PAVEMENT DESIGN STUDY  
GRANDWOOD RANCH  
FAIRPLAY DRIVE AND HIGBY ROAD  
MONUMENT, COLORADO  
80132

PROJECT NUMBER 21-1238  
JULY 26, 2021

Please add "PCD  
File No.  
SF-20-026".

**Figure 2**

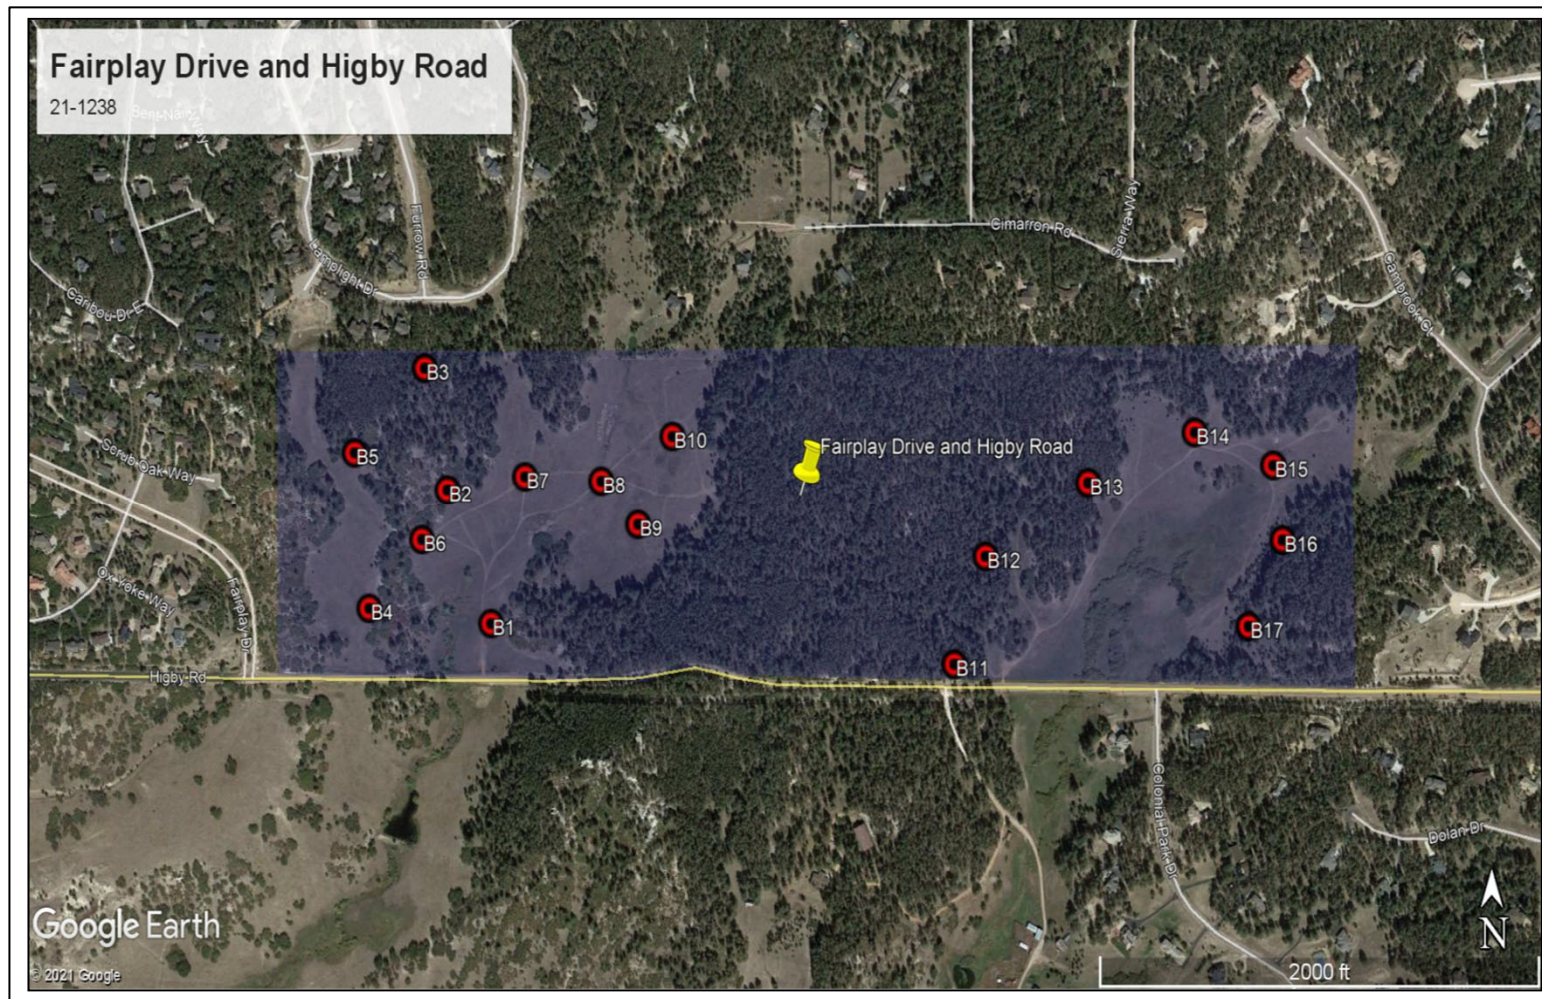
Please provide a scale. Note that per ECM D.2.1 field investigations should consist of borings that are not more than 500 feet apart from each other.
